**MM12/21 MEADOWBANK EDUCATION AND EMPLOYMENT
PRECINCT - Mayor, Councillor Jerome Laxale**

City of Ryde Submission

MEEP - Schools Project Modification (SSD-9343-Mod-4)

Seeking to delete public domain works, footpaths, pedestrian crossing
and extension of construction work hours

Figure 1.27: Recommended Moderate Scenario Cycling Infrastructure

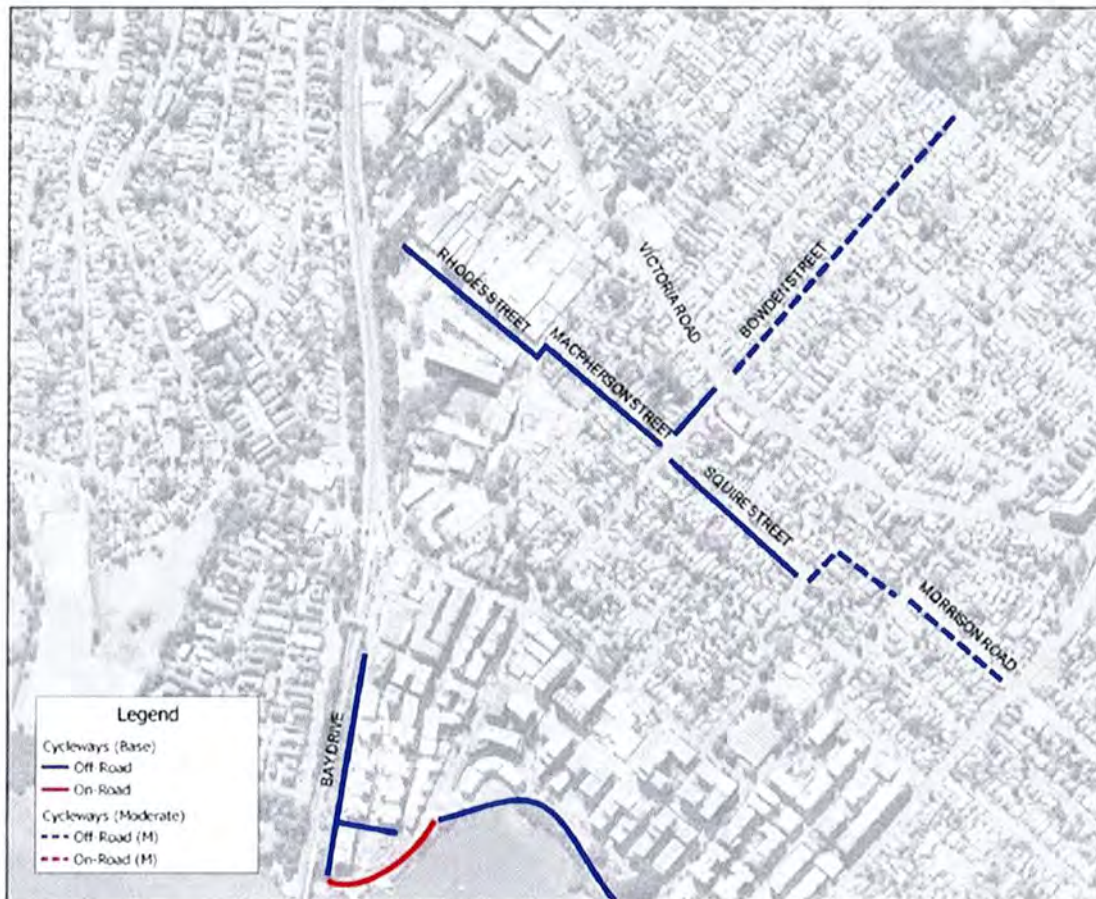
The proposed reduction in the width of the cycle path contradicts the recommendations provided within the latest Draft Transport Plan (School Travel Plan) prepared by GTA Consultants/ Stantec on behalf of the applicant dated 8 November 2021.

The Report was prepared to address Condition D17 of the consent, whereby section 1.7.2 of the Plan specifically recommends for an off-road cycle path within Squire Street. See extract below of Figure 1.27 of the Plan for reference.

A concession for a reduction to the width of the off-road path (from 2.5m to 1.35m) along the southern side of Squire Street can be considered provided other works such as the provision of a 1.2m wide footpath along the western side of Hermitage Road in addition to the 2.5m wide shared user path (as previously recommended by Council staff and shown within the approved Construction Certificate civil plans) can be delivered by the applicant, which would be considered an appropriate trade-off. A 1.2m wide footpath on the western side of Hermitage Road would provide safe access for pedestrians being dropped off/picked up on this side of the road.
